FINAL ENVIRONMENTAL IMPACT REPORT 1299 Sansome Street Office Building 81.415 E

FINAL ENVIRONMENTAL IMPACT REPORT 1299 SANSOME STREET OFFICE BUILDING 81.415 E

- Changes or additions to the Draft EIR are indicated by solid dots at the beginning of each revised section, paragraph, table or figure.

●Figure No.15

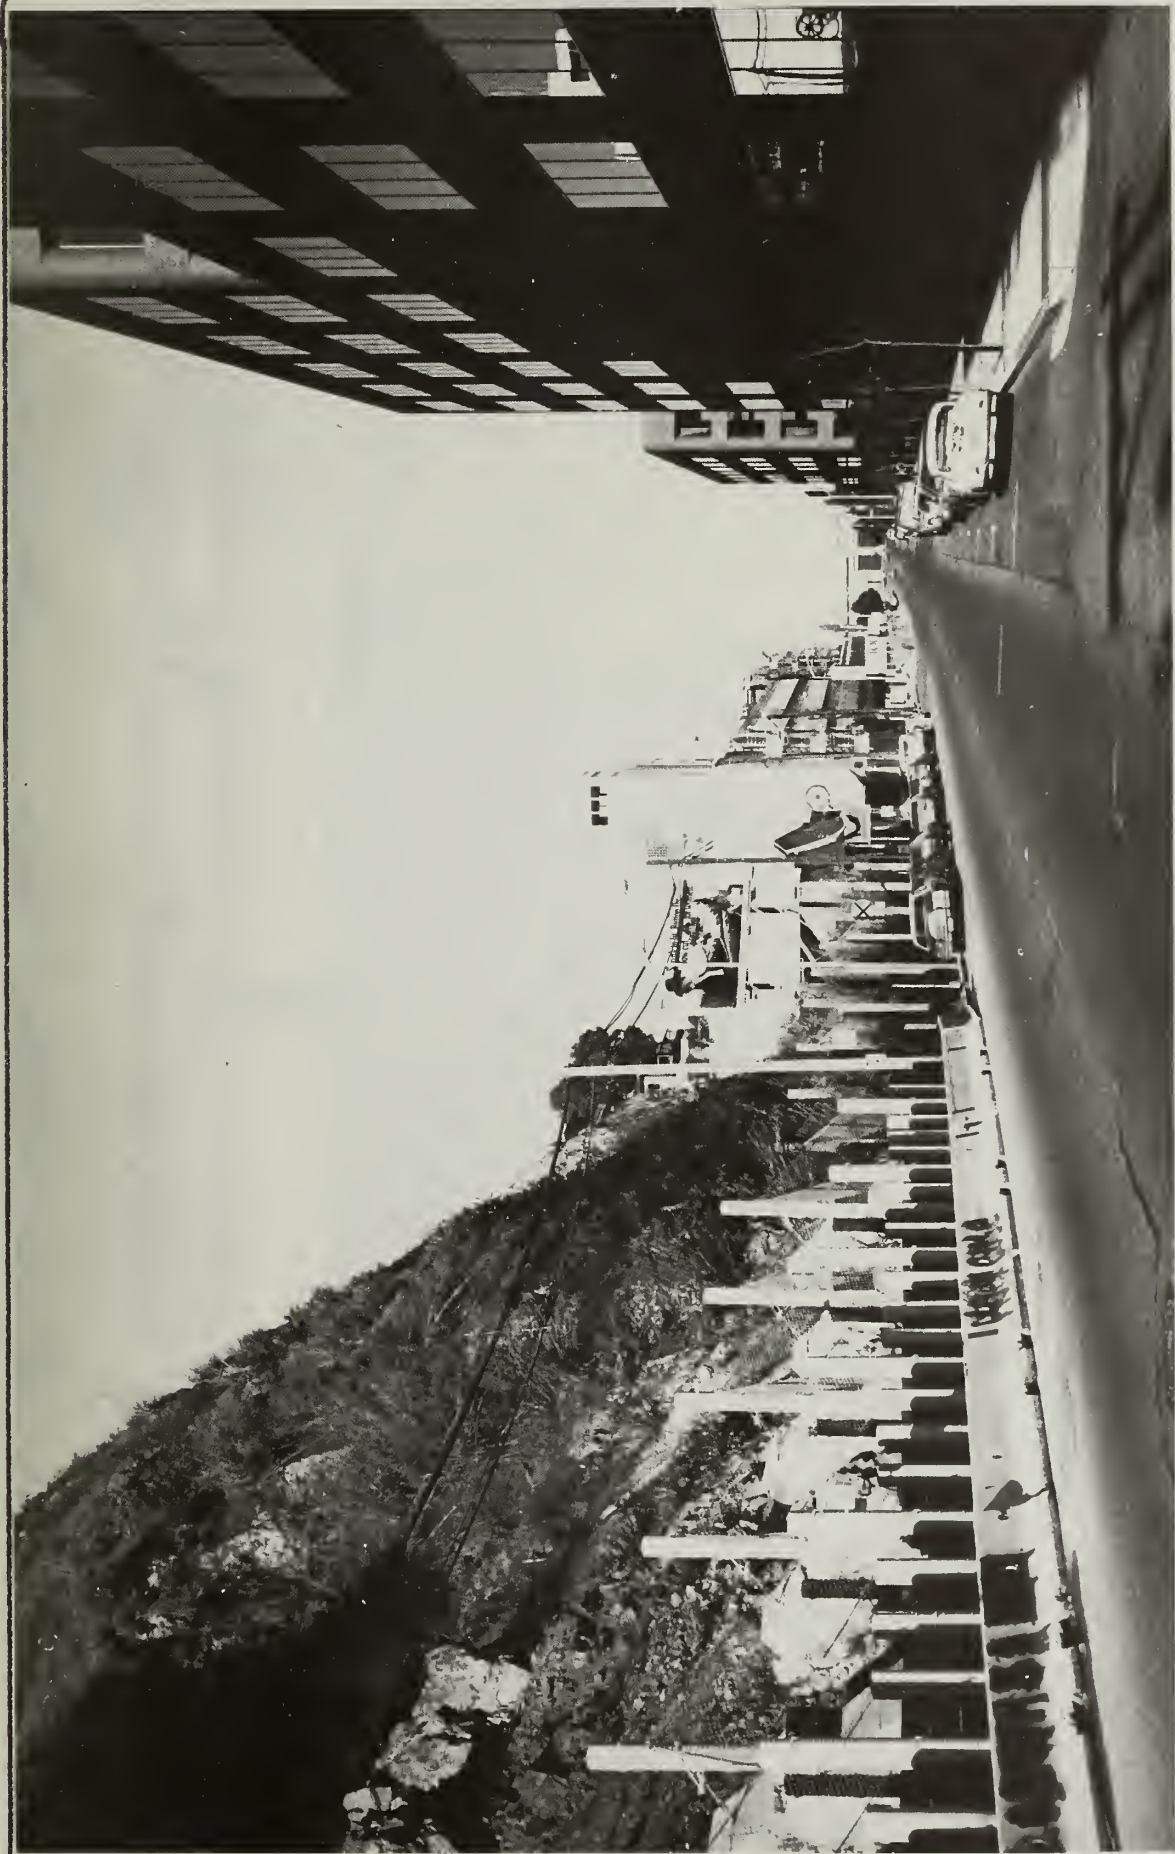
"Page 34, 35 and 36 shows the building outlined, and it shows the trees and the cliff coming through that outline. And it seems to me it should fill in that building, so that you really see what the building is. It should be, in each of those, a solid building, and then show the cliff, so that we are really getting a picture of what will be disappearing."

Figures 15, 16 and 17, pages 34, 35 and 36 have been modified to show the project site without the proposed structure, and to then show the project site with the proposed structure superimposed on the figures. The building's profile has been darkened to more clearly illustrate those features of the existing setting that would be obstructed from view. To make this change, Figures 15A, 16A and 17A have been added to the EIR, pages 34A, 35A and 36A.
